Common Mode Comment Recommendations 101,102,103,104,105

January 2022 IEEE 802.3ck Interim

IEEE 802.3 100 Gb/s, 200 Gb/s, and 400 Gb/s Electrical Interfaces Task Force January 12, 2022, ad-hoc meeting

Proposal 1: Separate CM voltage specification by frequency Comment: # I-101 & # I-102

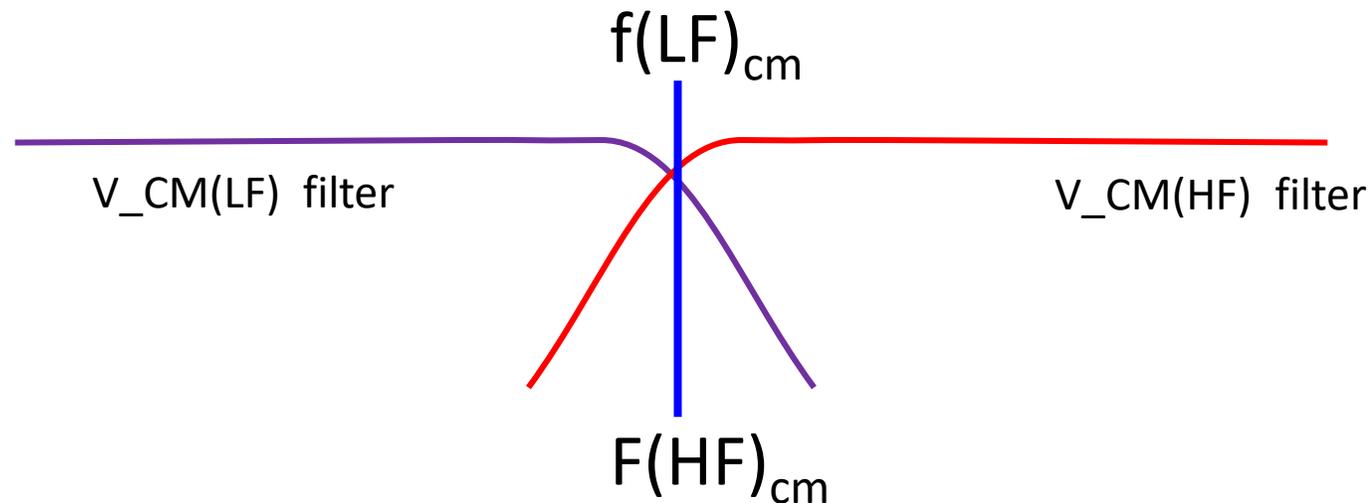
- ❑ Separate low and high frequency measured common mode voltage
 - $V_{CM}(LF)$ is V_{CM} filtered with a low pass 4th order Bessel Thomson filter with 3 dB point a $f(LF)_{cm}$
 - $V_{CM}(HF)$ is V_{CM} filtered with a high pass 4th order Bessel Thomson filter with 3 dB point a $f(HF)_{cm}$
- ❑ $f(LF)_{cm} = f(HF)_{cm} \rightarrow 100$ MHz
- ❑ It's understood that applicable complementary LF/HF CM specification are to be adjusted accordingly, such as "Common-mode to differential-mode return loss, $RL_{dc} (min)$ ", "Differential-mode to common-mode return loss, RL_{cd} ", "Common-mode to common-mode return loss, $RL_{cc} (min)$ ", "Differential-mode to common-mode insertion loss, Il_{cd} " and "Common-mode to differential-mode insertion loss, Il_{dc} "
